From: Joe Russell-Wells
Sent: 14 December 2012 15:30
To: Neil Crowther
Subject: FP/155/12/DOC - Conditions 10, 11 and 19

LEAP, Blakes Mead - Felpham

Landscape Plan
Barrett Homes - Southampton

5508

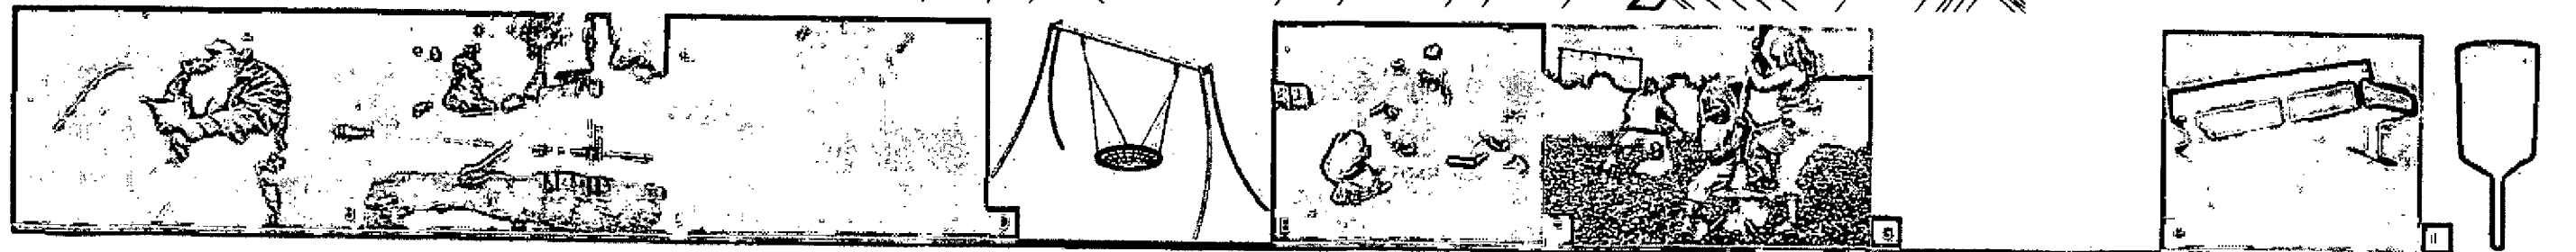
LEAP dwg 5508

- Specify colour of bow top fencing – note powder coated but no colour specified
- One item not labelled - balance beam? Mound overlays this item – further clarification needed
- J - please specify type of rubber matting and fixing arrangement
- I - litter bin as per ADC specification needs to be included – omit 'Orchard' bin
- The detail of the landscaping indicated as integral to the play area needs to be provided – this does not form part of previously approved plans.

Following our earlier meeting I can confirm that the LEAP as you describe is now satisfactory and I believe satisfies partial approval of Condition 10 of FP/151/12/DOC and FP/155/12/DOC in relation to Phases 1 & 2. I do require to know the species for hedge and tree planting associated with the play area – please provide details.

I confirm the proposed planting is fine.
